Campaign Update CA#9772

Subject: The Xantrex Inverter Electronic Breaker
Affects certain 2021 Wonder Motorhomes

Customer Service: Wonder Xantrex Inverter for 30amp Breaker (GAAR 9772)

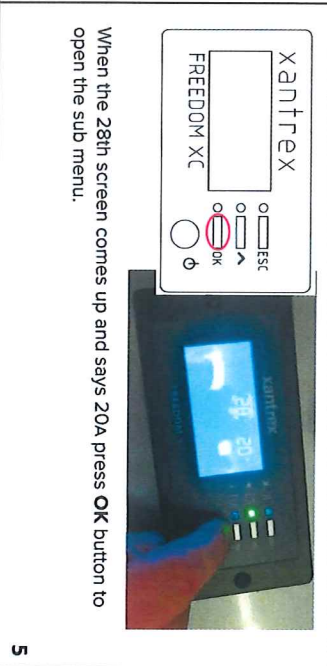
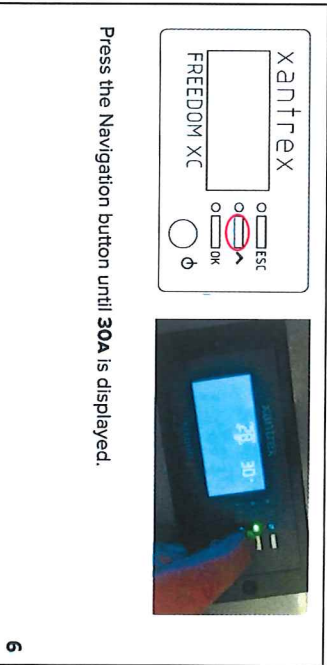
When the 28th screen comes up and says 20A press OK button to open the sub menu.

Press the Navigation button until 30A is displayed.
